**ONSITE SEWAGE DISPOSAL SYSTEM**

PROPERTY ADDRESS: 2914 Winterhazel Court

SUBDIVISION: Belle Haven Estates

Reference: Belle Haven Estates, Lot 30  
2914 Winterhazel Court  
BAT Site Plan  
DDC Project No.: 06116.5

SEPTIC SYSTEM PROFILE  
 LOT 30  
 SCALE: HORIZ. 1"=30'  
 VERT. 1"=8'

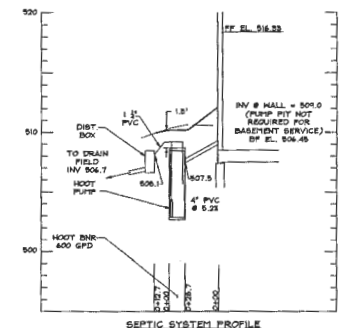
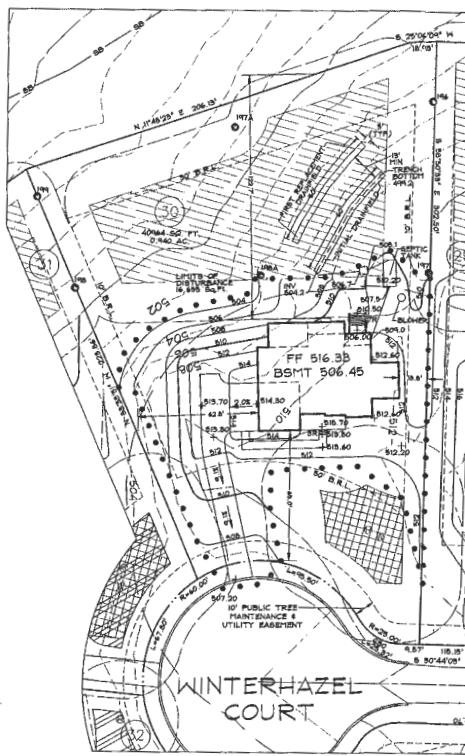
- Scale label 1"=30'
- Include 507.2' trench ground elevation at the beginning of trench.
- Pipe slope % from tank to D-box
- Pipe slope % from d-box to field
- Show riser and top tank elevation on septic system profile
